VALUE ENGINEERING STUDY REPORT

Operations Buildings Poplar Island

Baltimore District US Army Corps of Engineers

17 March 03

A - 08

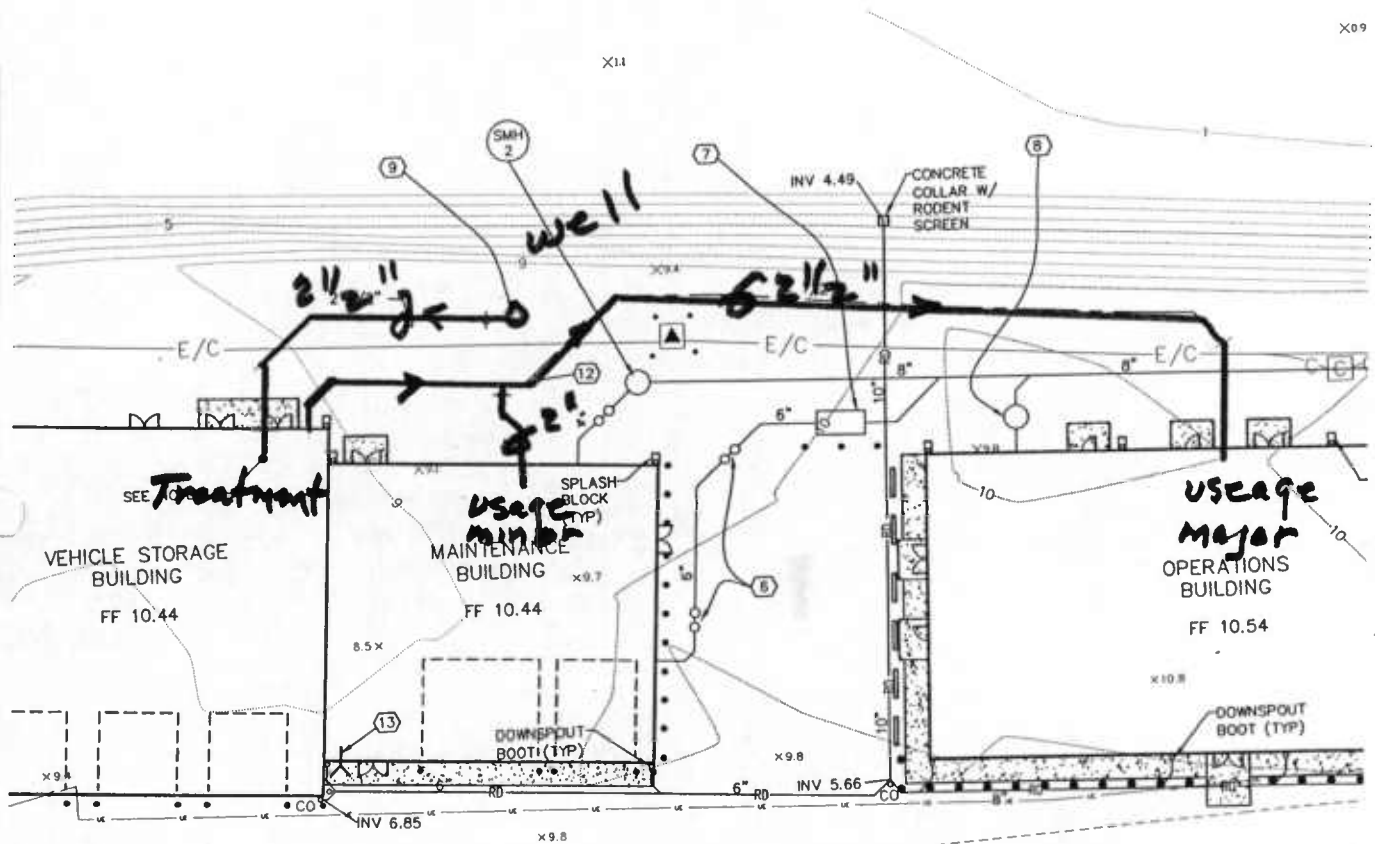
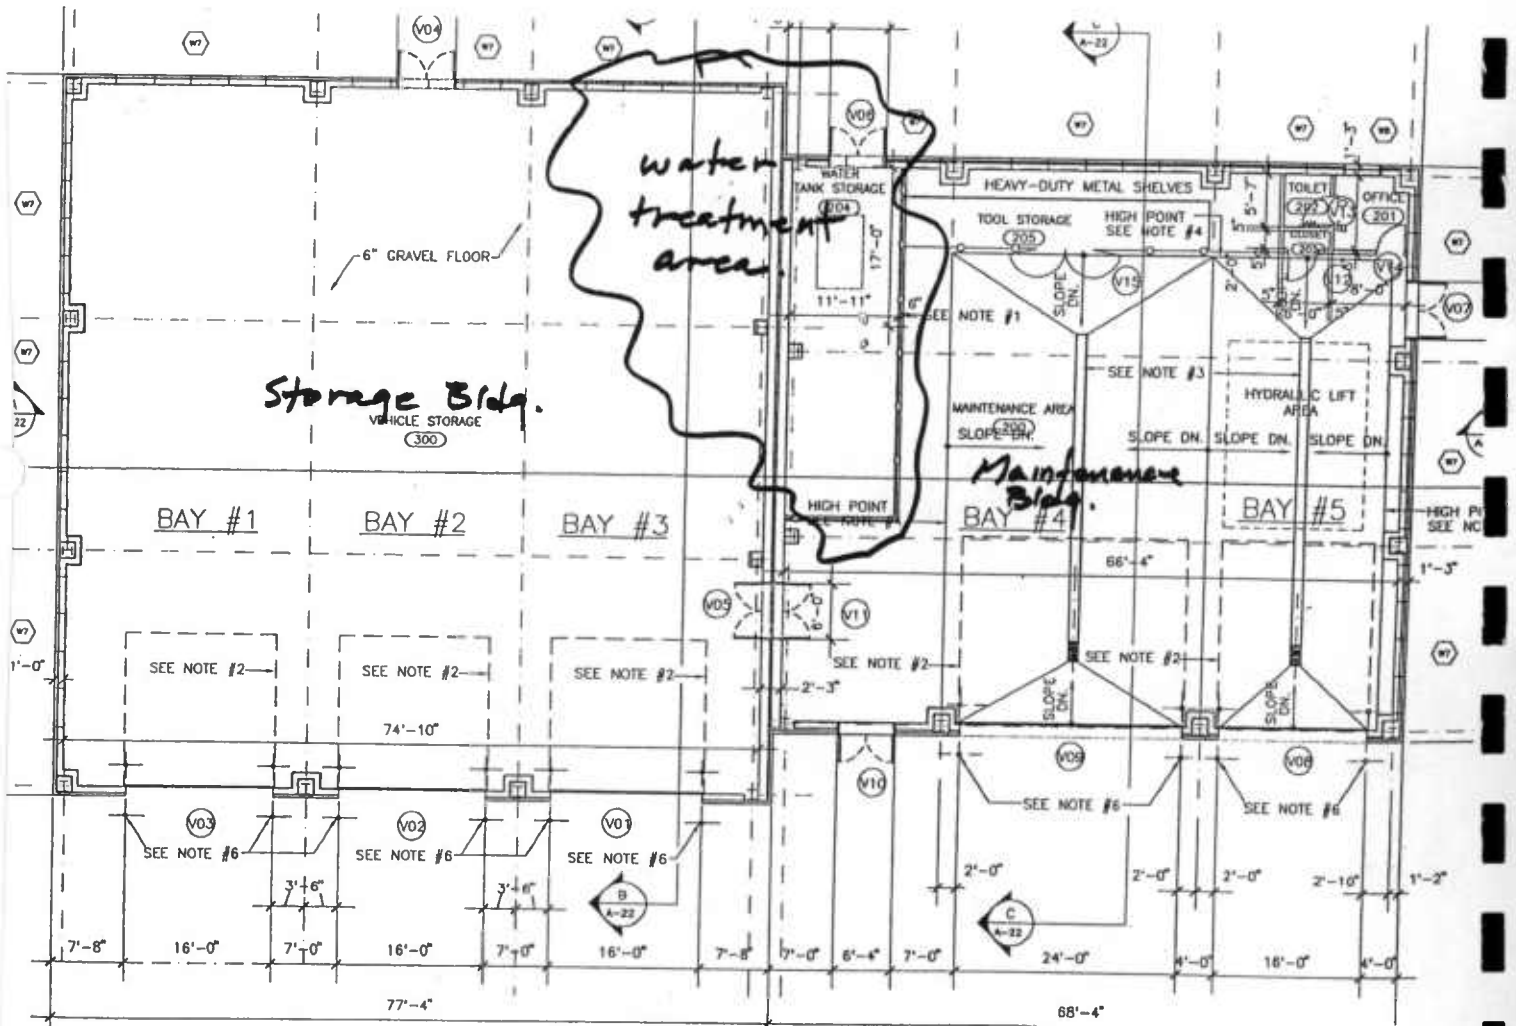
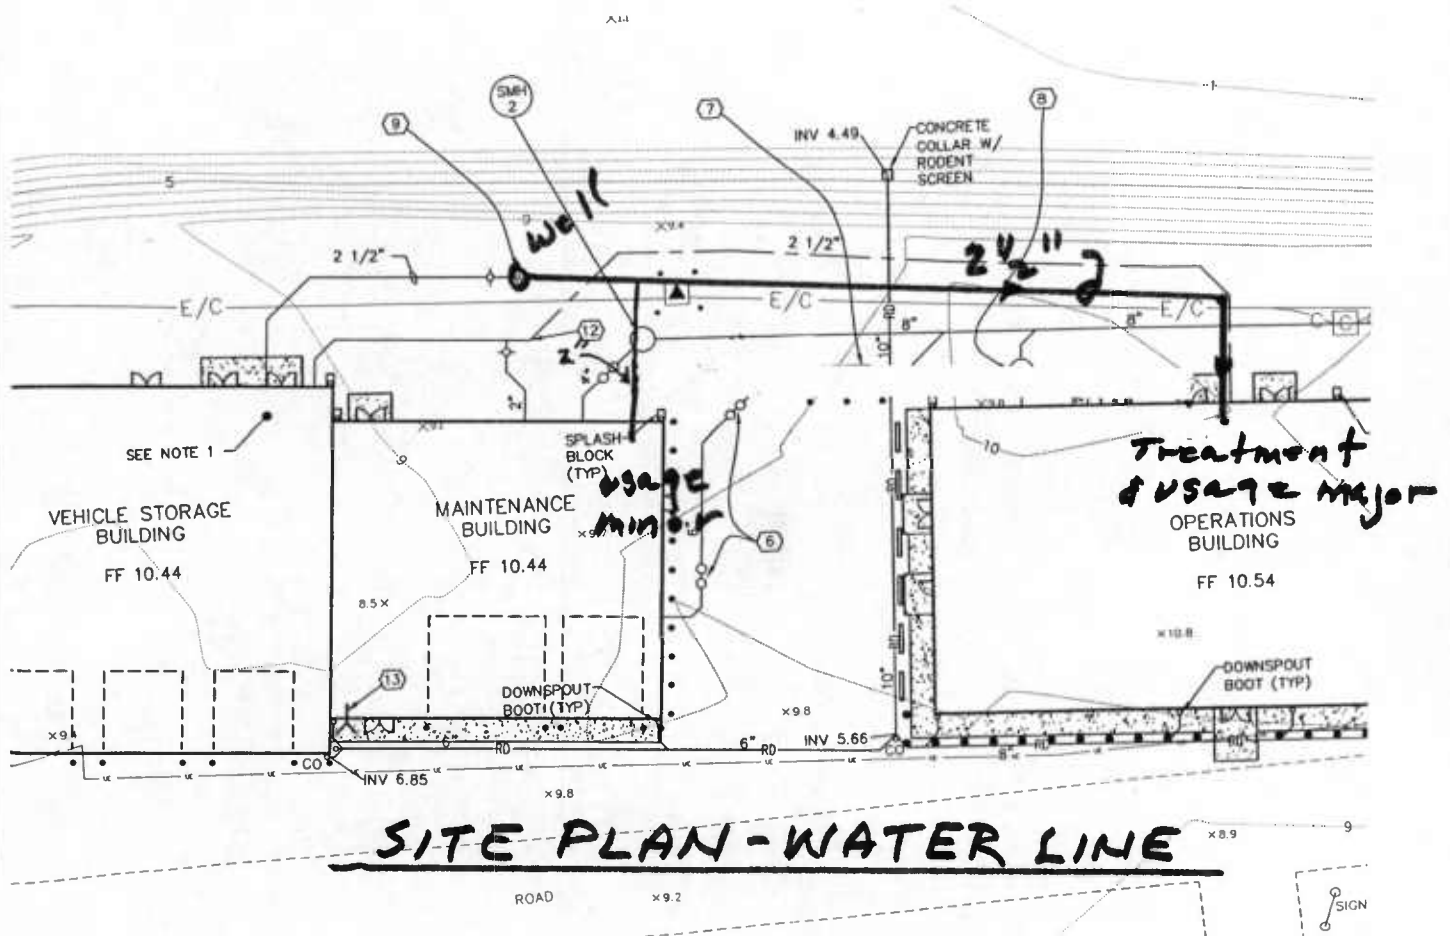
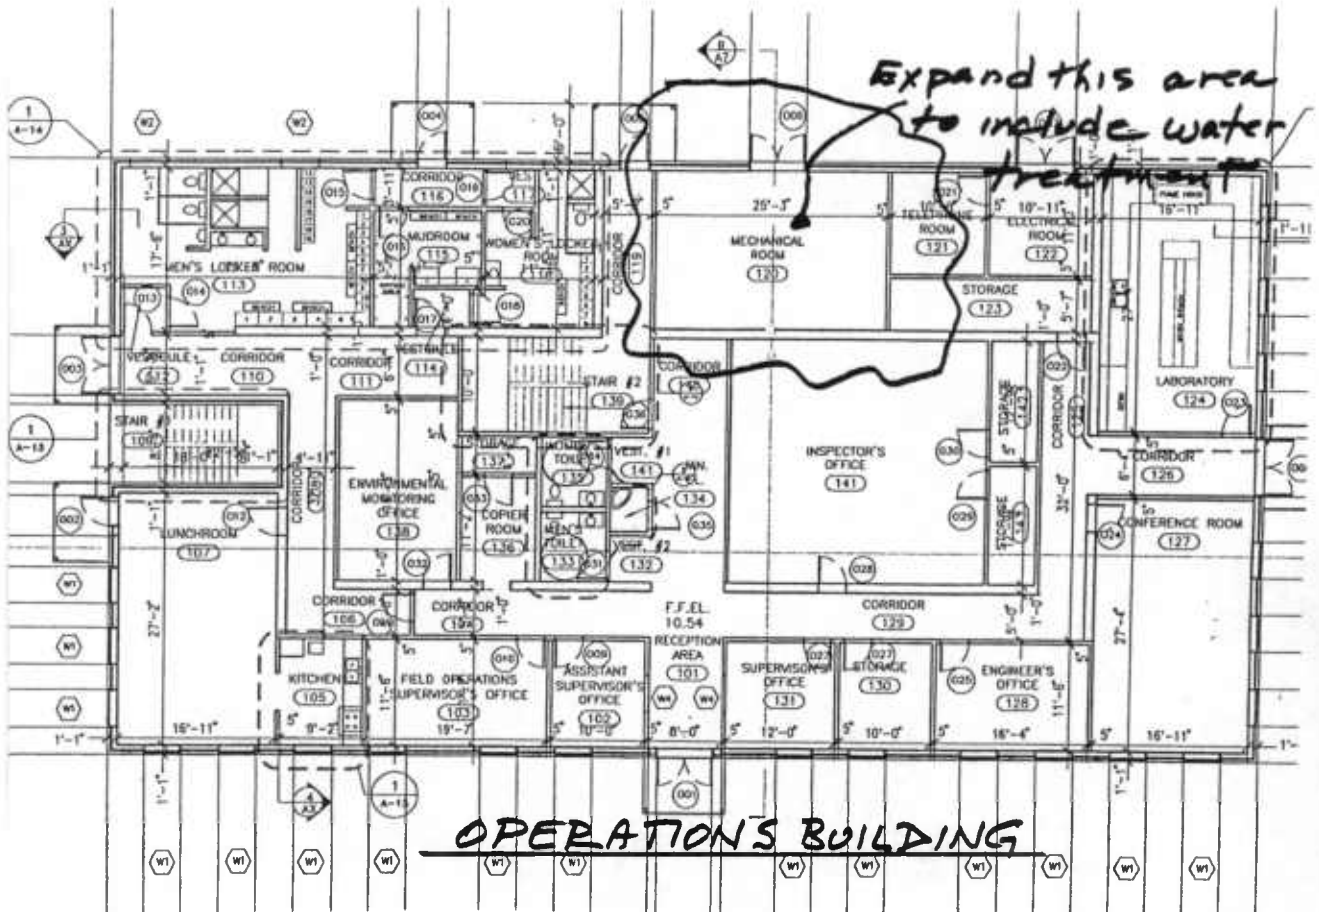
JUSTIFICATION: The water well is located behind the vehicle maintenance building. Untreated water under the original design is pumped west to the treatment area in the storage building, thence treated water is pumped east to the main usage point, the Operations Building. Under this proposal, the treatment area is located at the Operations Building which is also the main usage point. The two toilets and lavatories in the Vehicle Maintenance Building will use untreated water.

A - 17

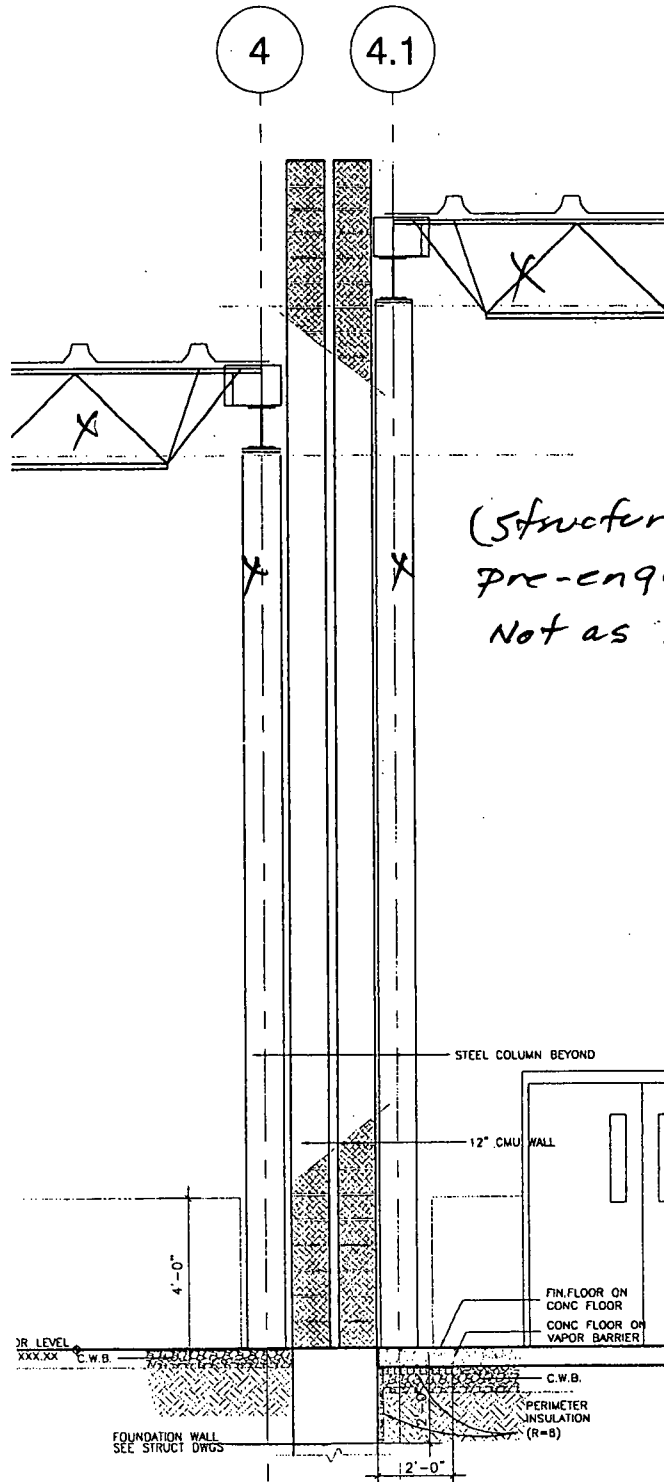
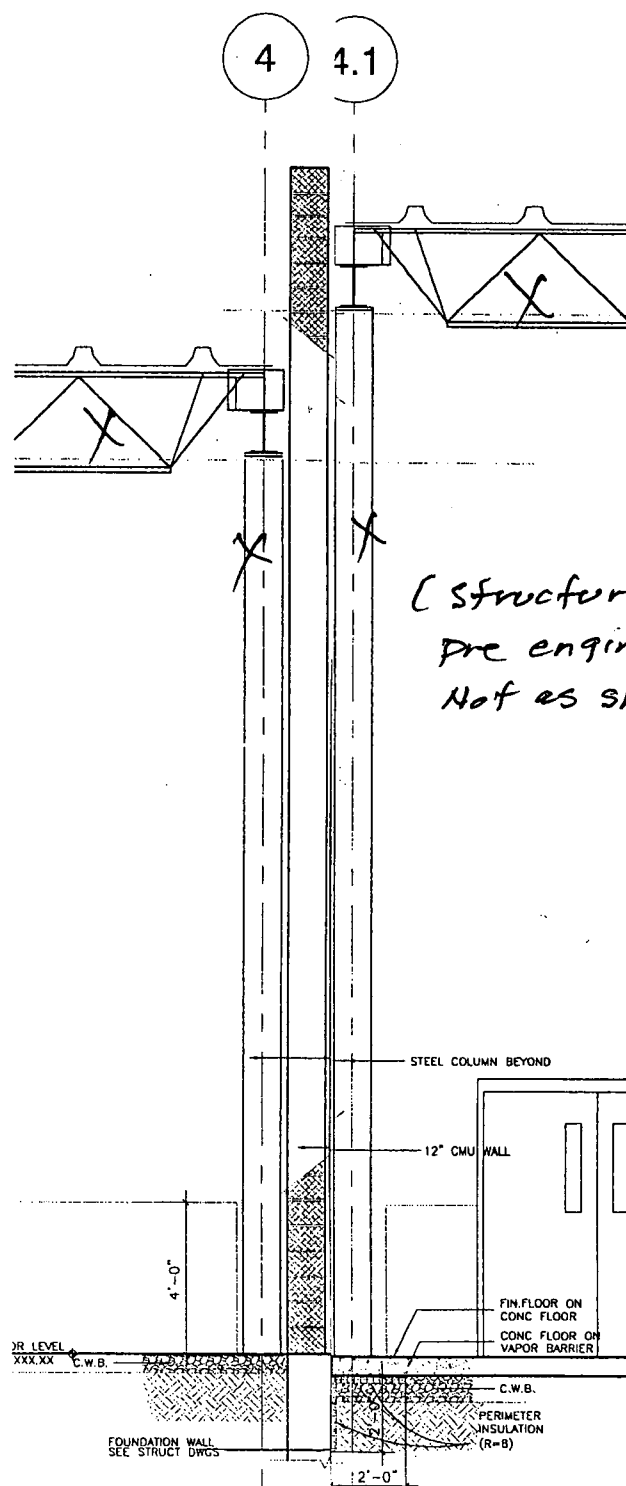
JUSTIFICATION: This separation was indicated to have a 3 hour fire rating. The actual fire separation rating should be determined. It is believed that one 12" thick CMU wall would be adequate. A double wall is unnecessary. Both structures would be built at the same time, so closure of one is not a problem.

A - 36

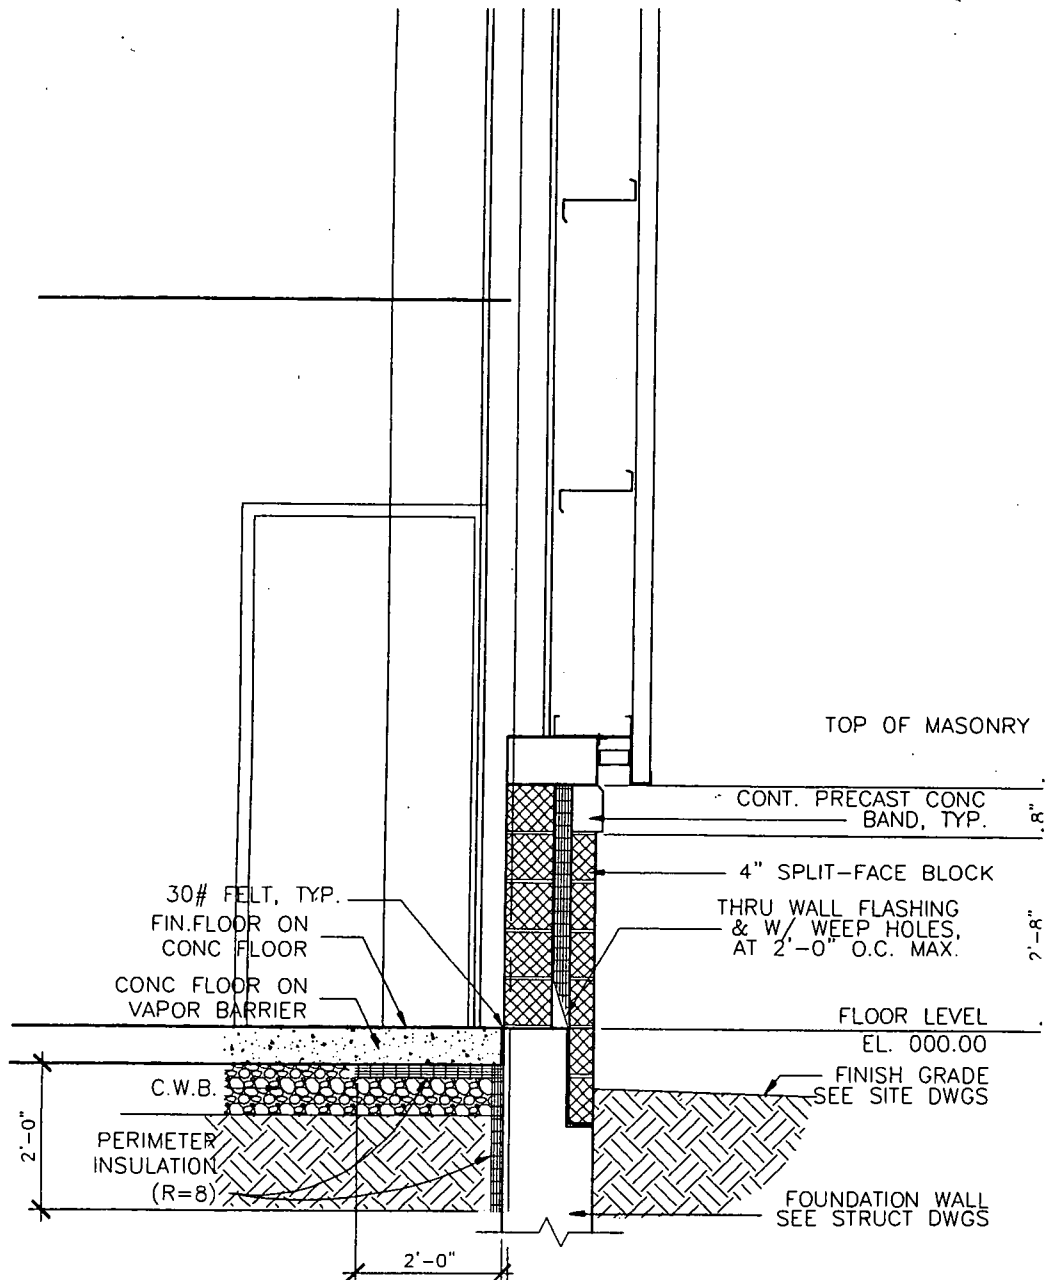
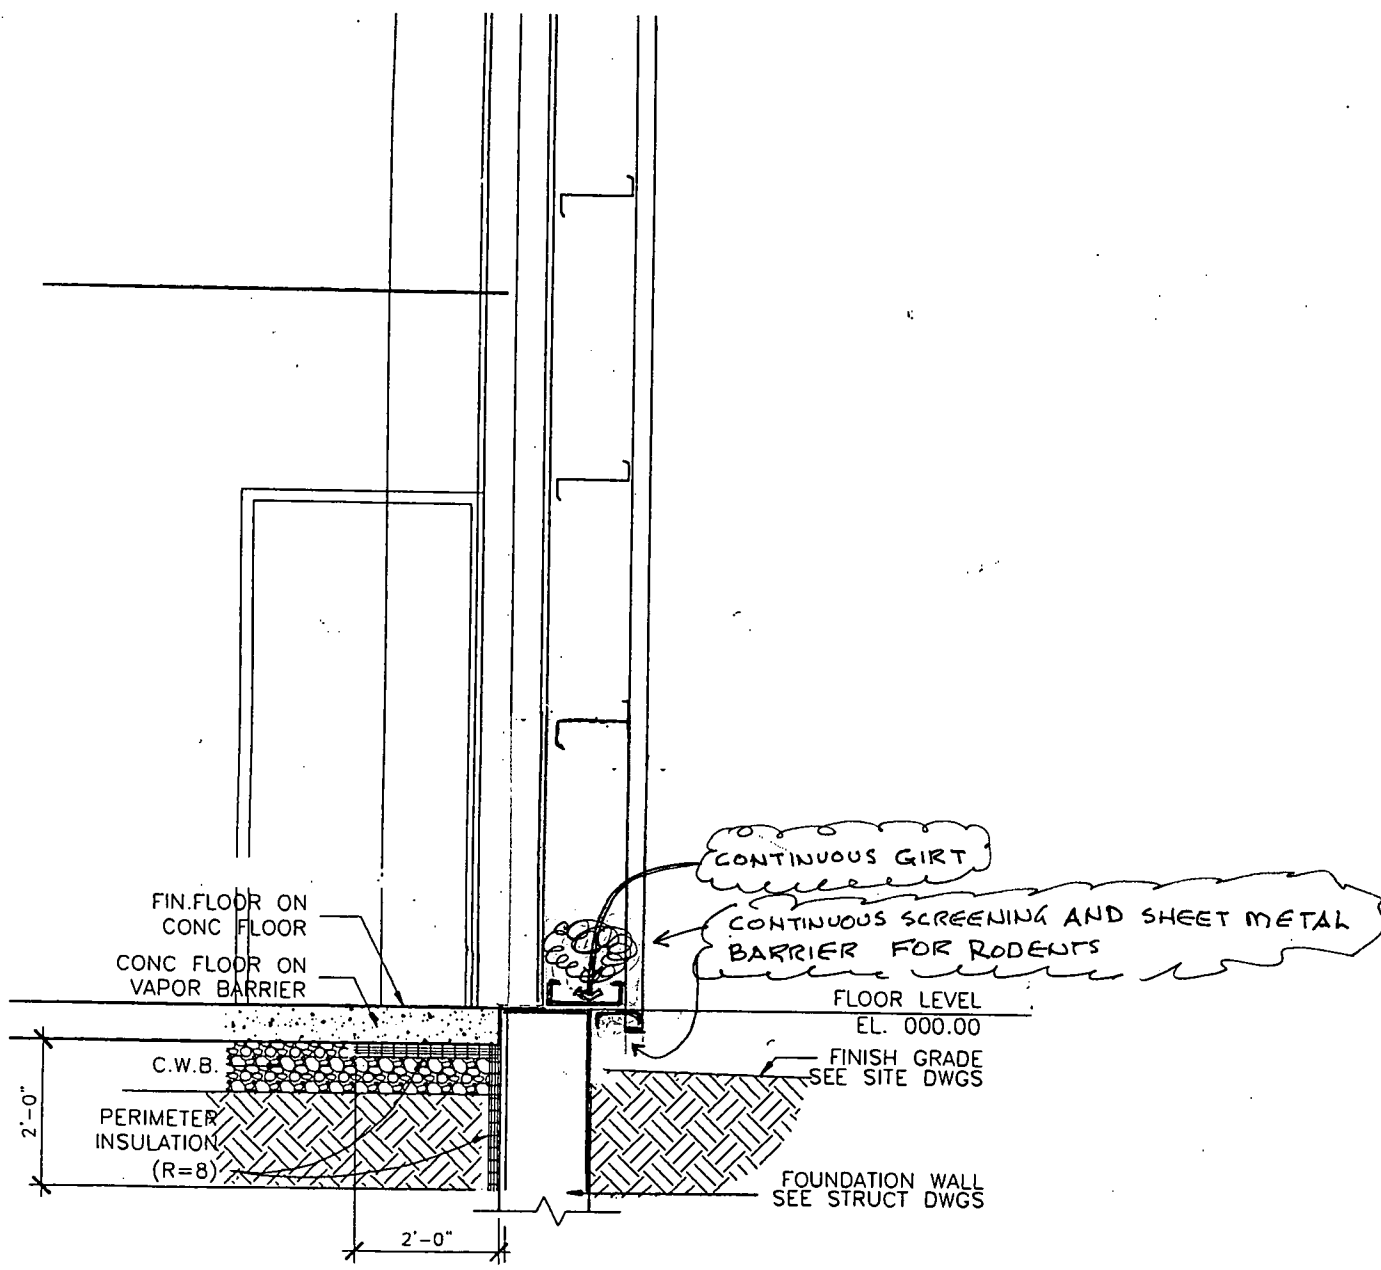
PROPOSED DESIGN: Delete the masonry portion of the exterior wall and extend the pre-fabricated metal panels. Install shaped sheet metal and screening at base to control rodents.

JUSTIFICATION: The primary purpose for using masonry veneer, as presented during the briefing, is to keep rodents (mice) out of the building. The proposed use of prefab metal panels with shaped sheet metal/screening at the base will accomplish the rodent control while allowing the benefits listed under "advantages."
